Notice of Proposed Amendment 2016-04

Maintaining aerodrome rules

CS ADR-DSN — Issue 3

RMT.0591 — 14.6.2016

Figure M-5. Light beams and angle of elevation setting of PAPI and APAPI

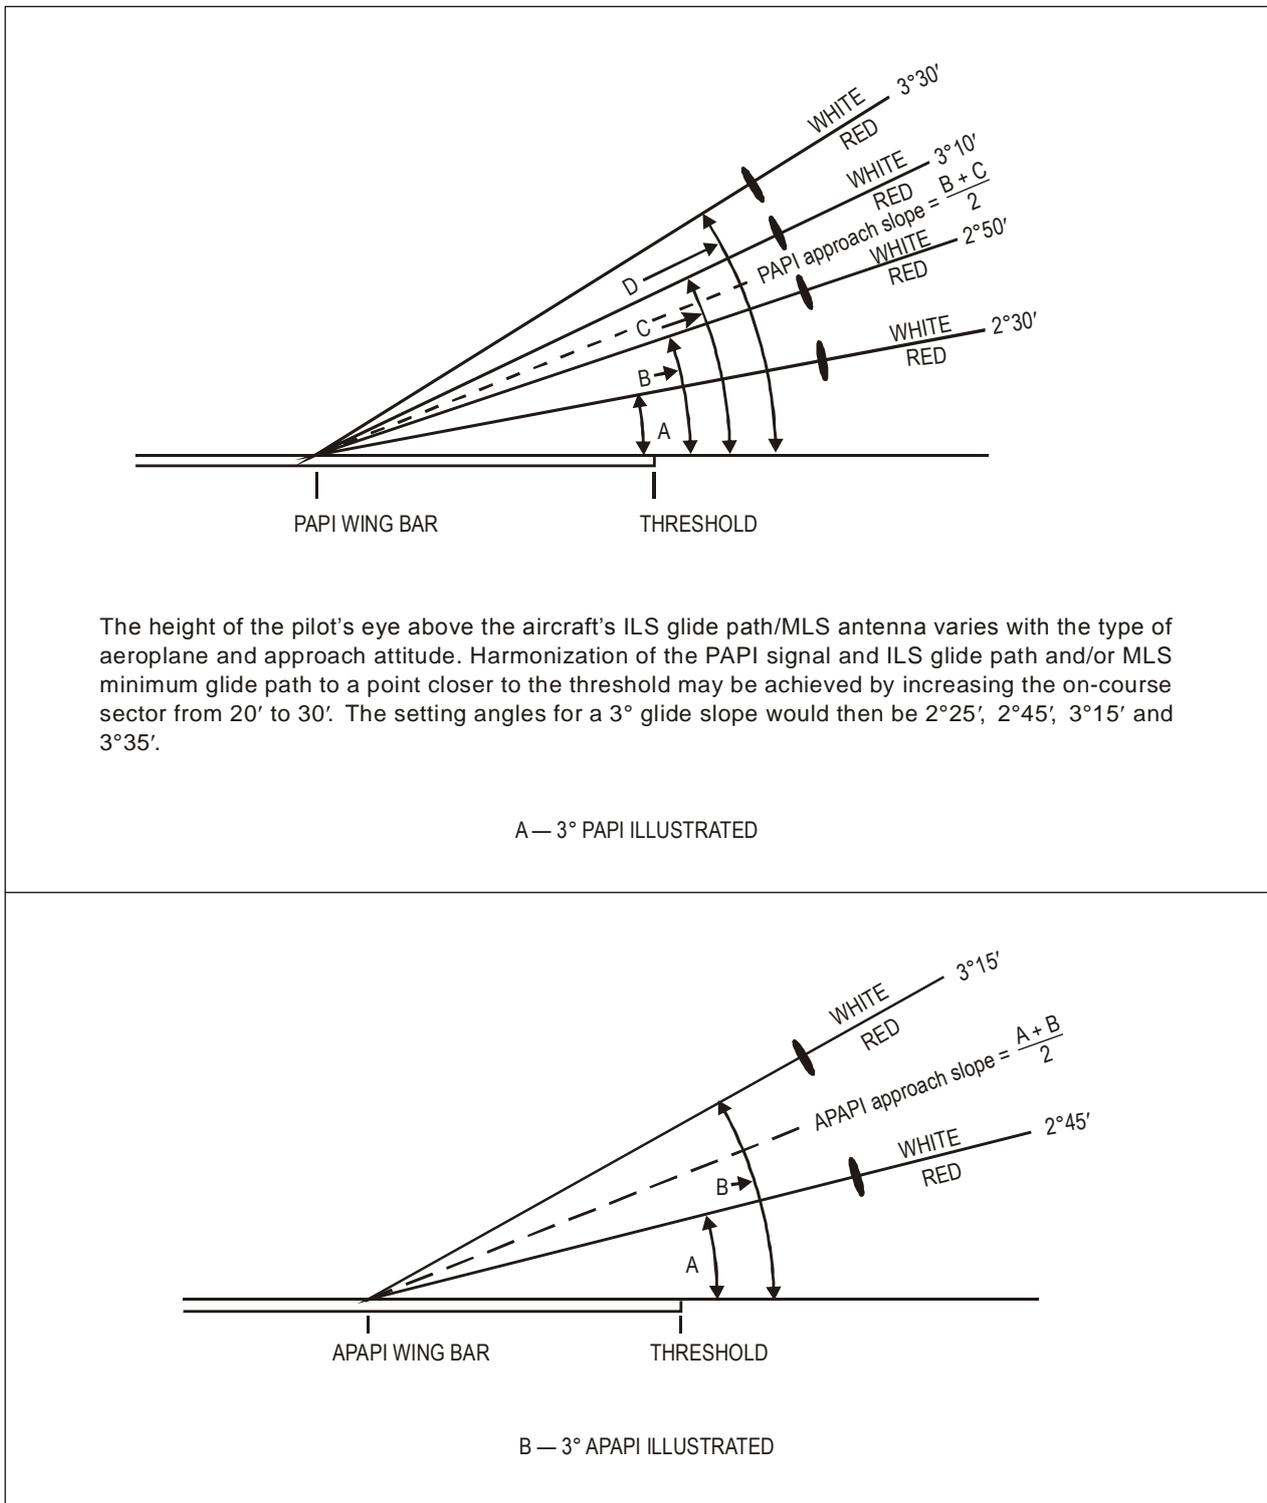
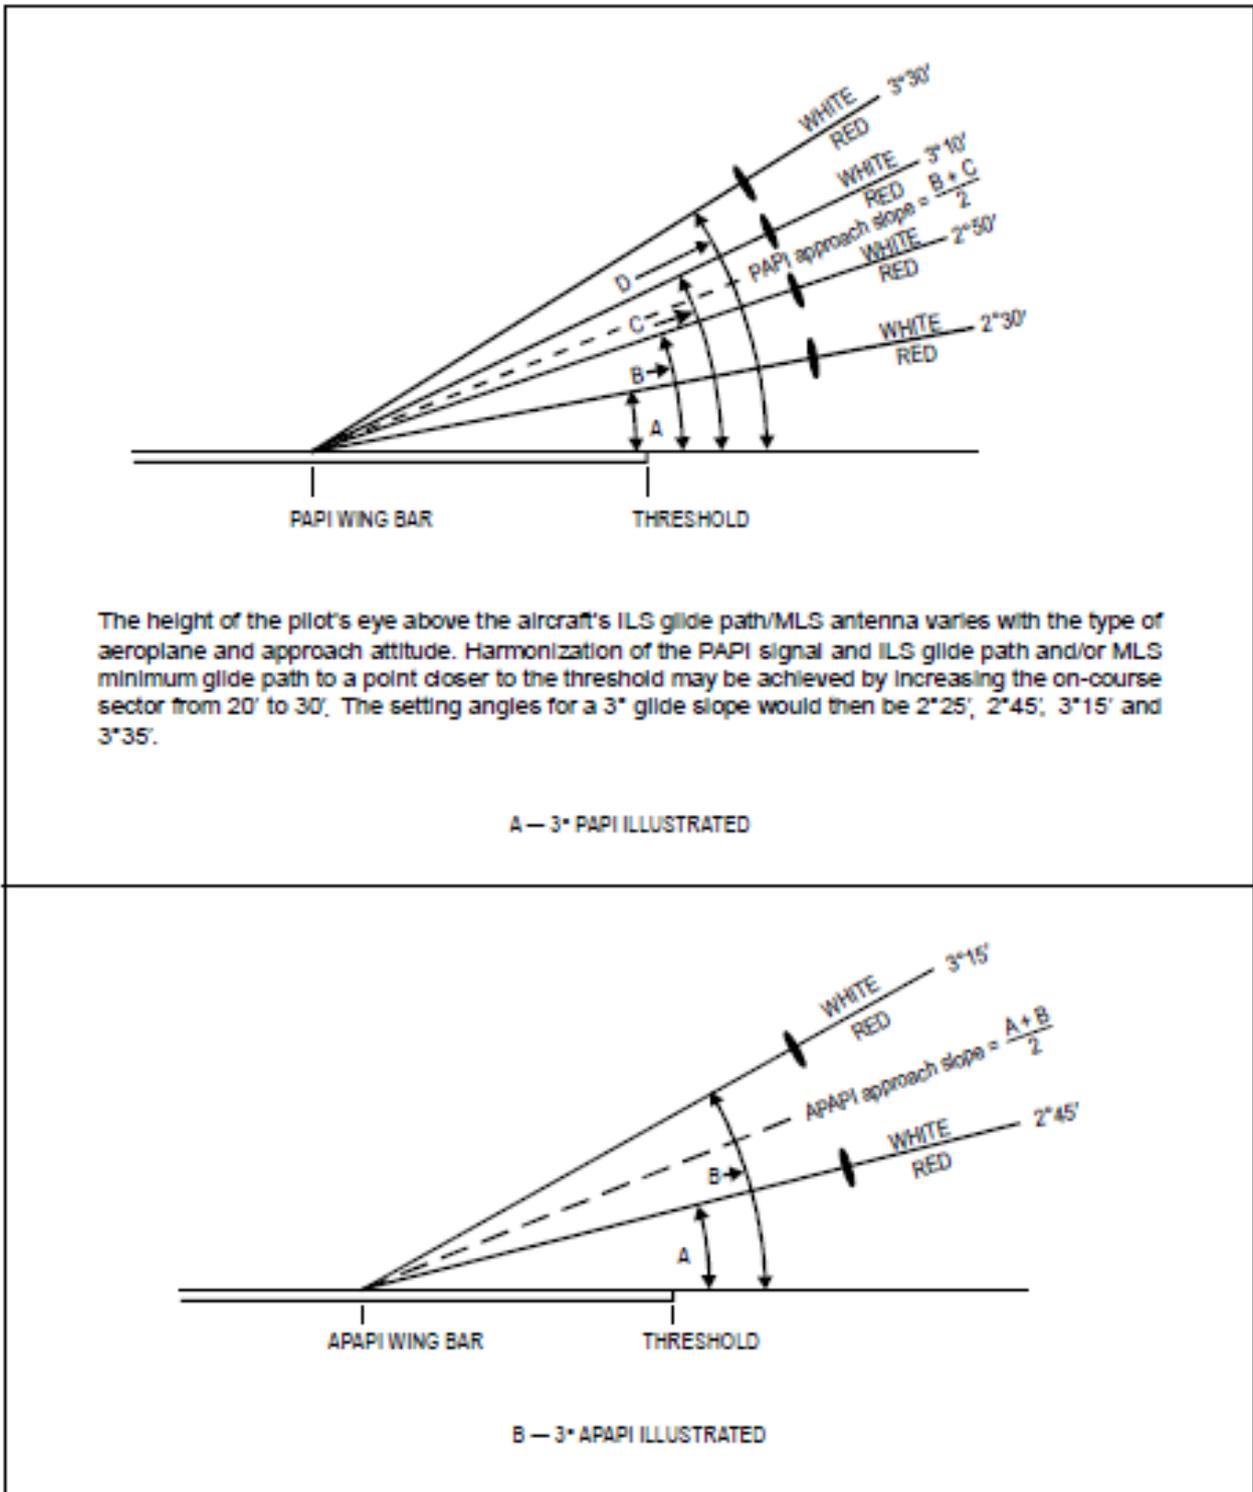
A new Figure M-5 is provided with better quality, without any change to its content.

[Editorial Note: Insert new Figure M-5]

[Editorial Note: Remove exiting Figure M-5]

Figure M-8(C). Simple touchdown zone lighting

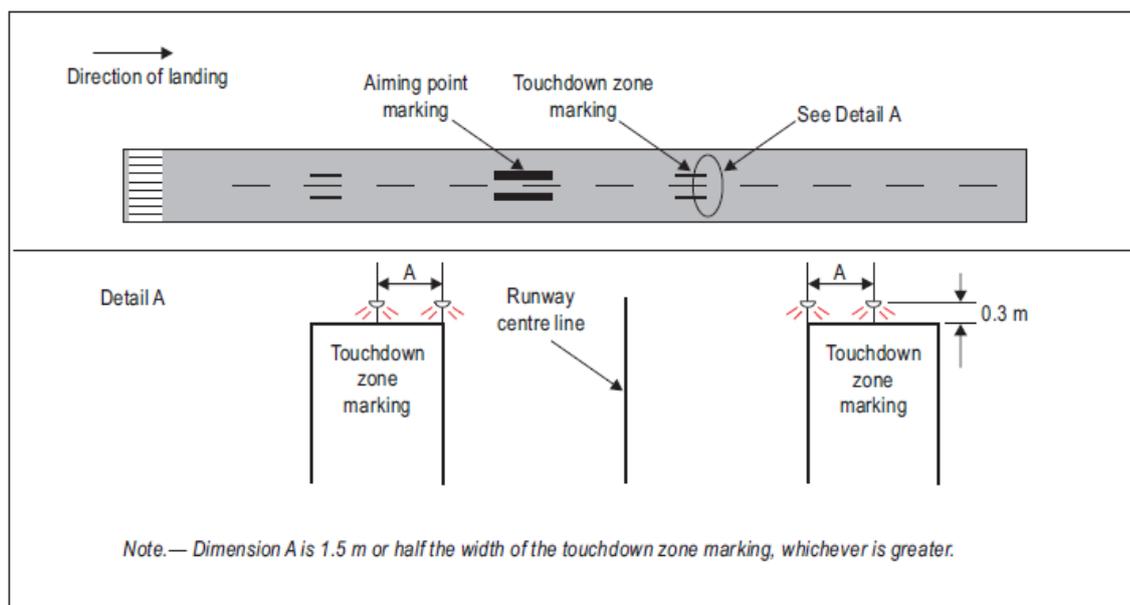
A new Figure M-8(C). 'Simple touchdown zone lighting' is added into the text.

- (1) Simple touchdown zone lights should be fixed unidirectional lights showing variable white and aligned so as to be visible to the pilot of a landing aeroplane in the direction of approach to the runway.
- (2) Simple touchdown zone lights characteristics should be in accordance with the specifications in CS ADR-DSN.U.940, Figure U-9.
- (3) Simple touchdown zone lights chromaticity should be in accordance with the specifications in CS ADR-DSN.U.930 and Figure U-1.

Figure M-10A. Runway starter extension lighting when the aircraft is assumed to backtrack (A) and when associated taxiway is used (B)

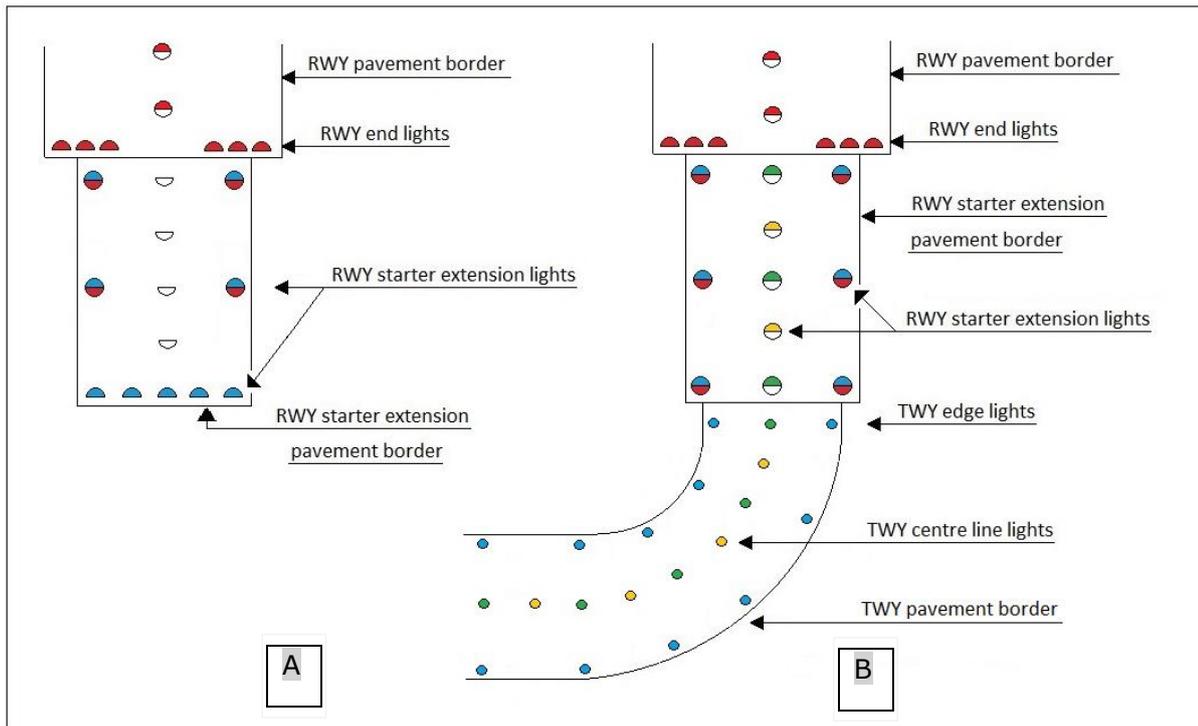
- (1) Edge lights of the runway starter extension should be fixed lights showing red in the direction of take-off and blue in the opposite direction (see Figure M-10A).

- (4) When the runway starter extension is not associated with the taxiway the centre line lights of the runway starter extension should be fixed uni-directional lights showing white in the direction of take-off (see Figure M-10A(A)).

- (5) When the runway starter extension is associated with the taxiway, the centre line lights of the runway starter extension should be fixed lights showing white in the direction of take-off. In the opposite direction of take-off uni-directional taxiway centre line lights should be provided showing alternately green and yellow (first and last light of the runway starter extension should show green), (see Figure M-10A(B)).

Figure U-1. Colours for aeronautical ground lights

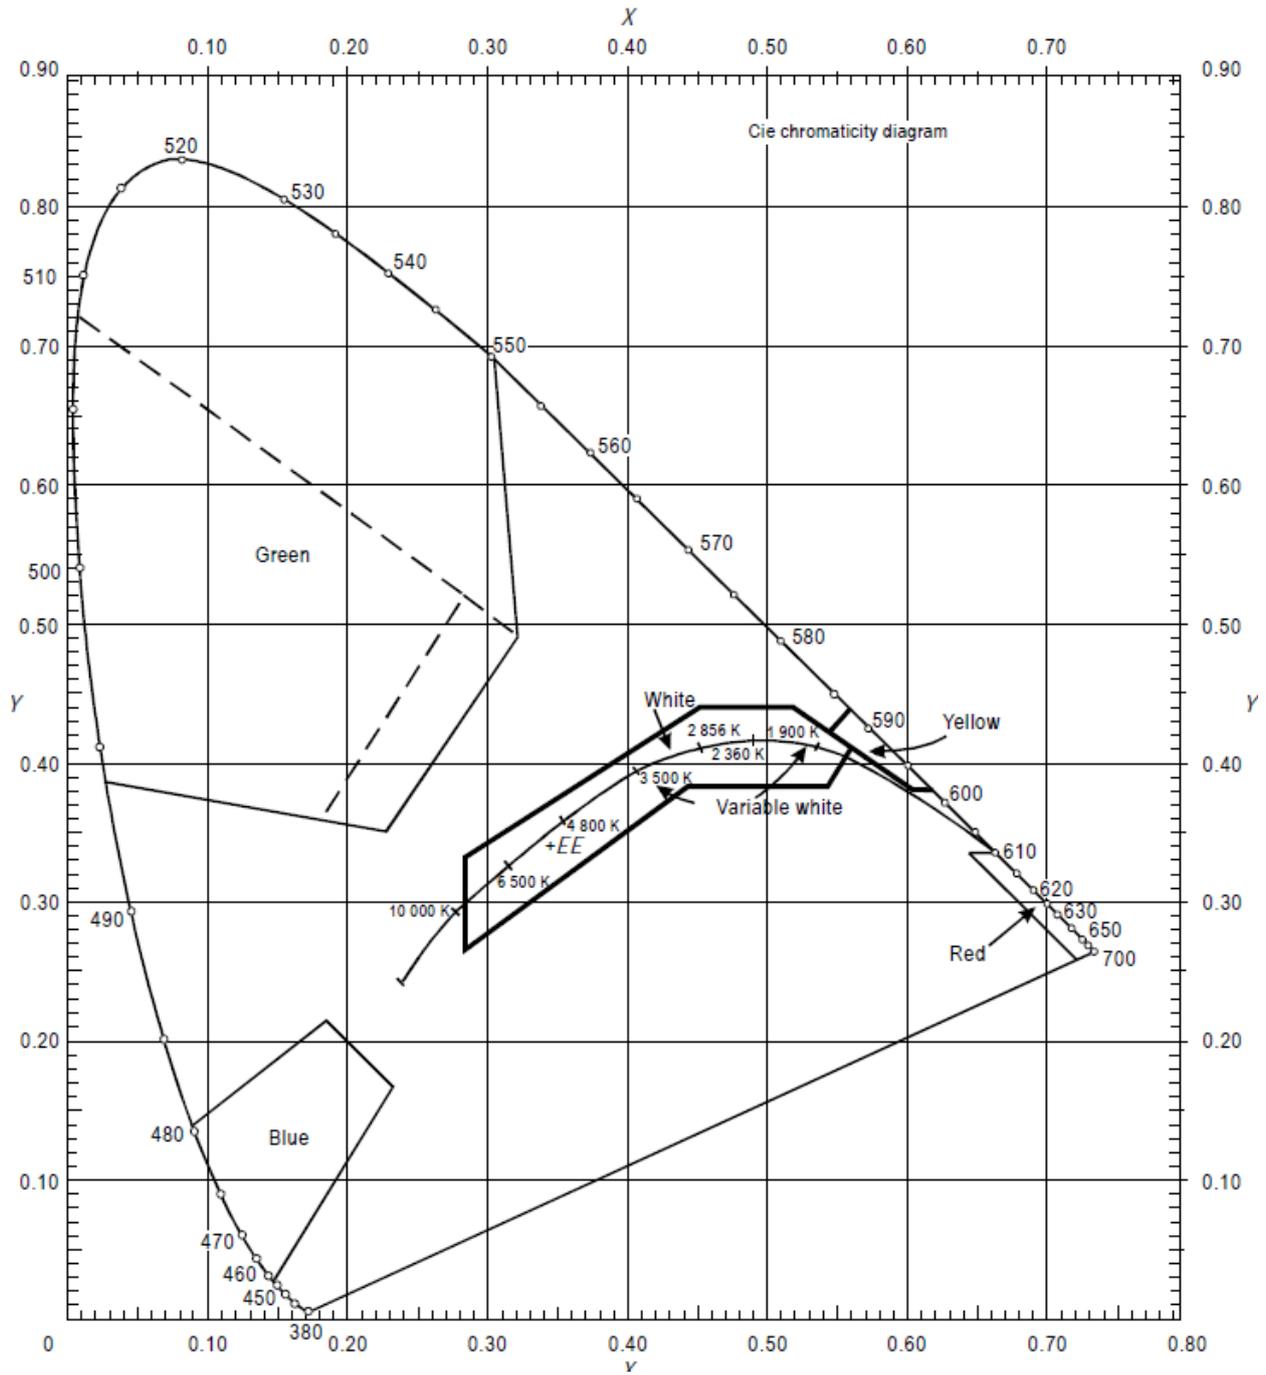
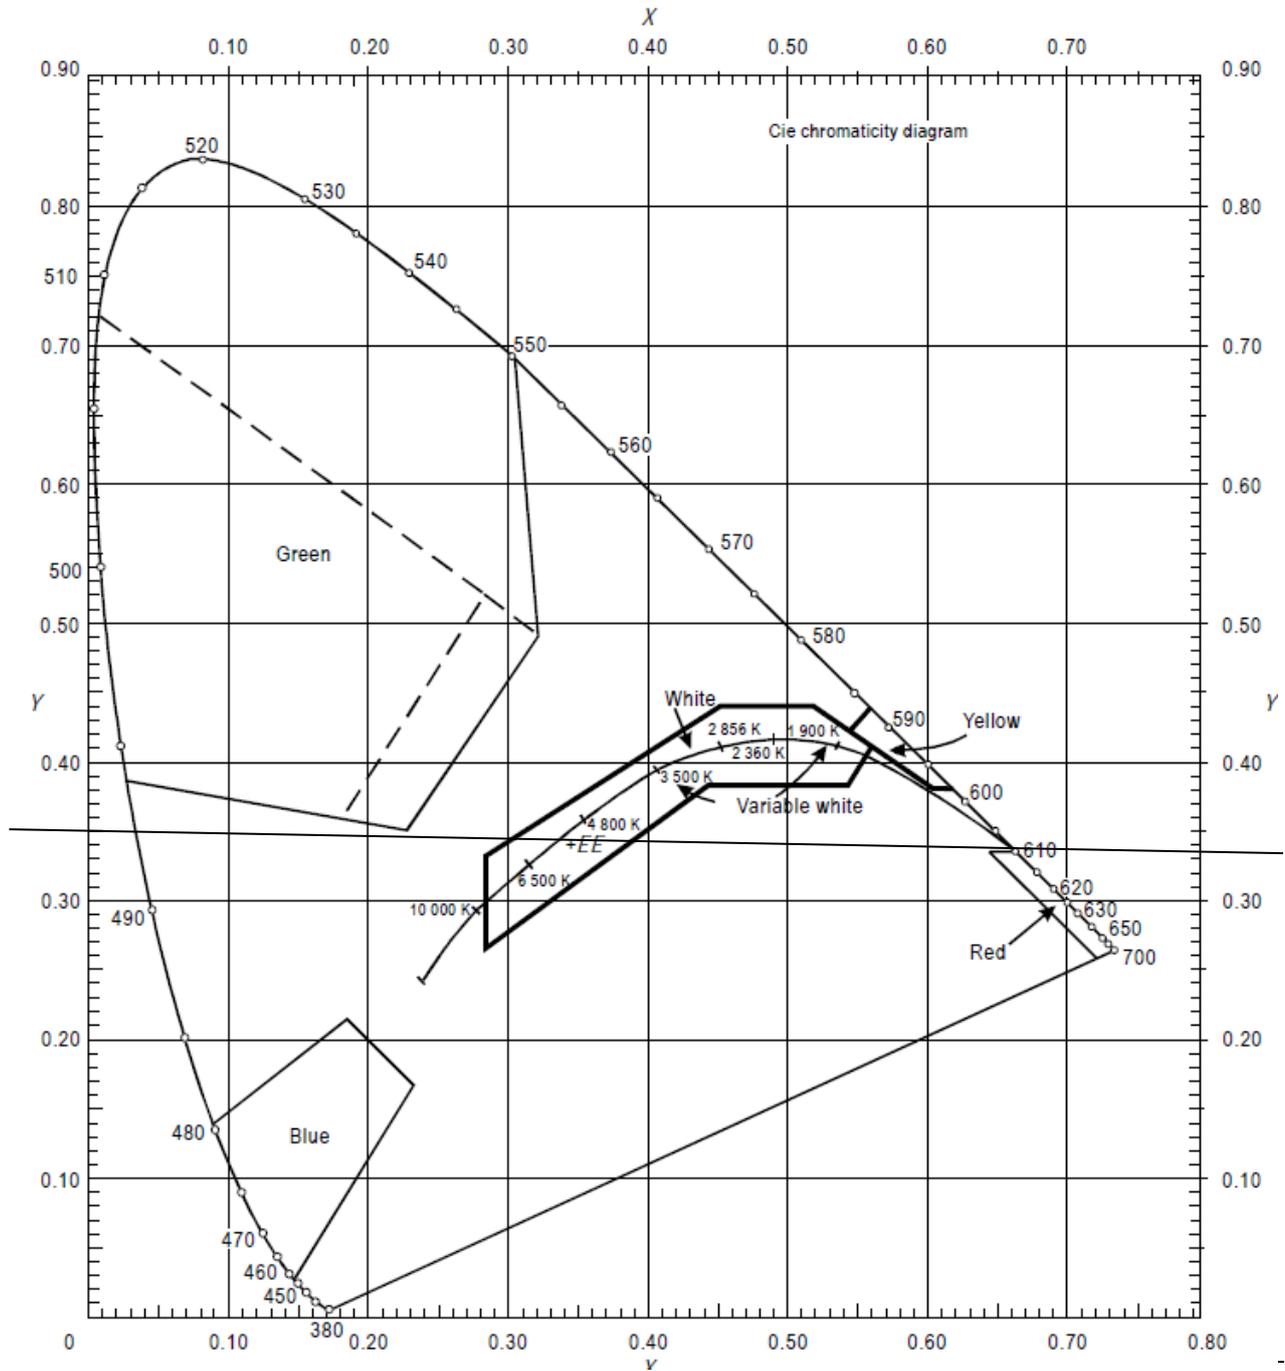
Figure U-1. 'Colours for aeronautical ground lights' is moved to a clearer position in the CS.
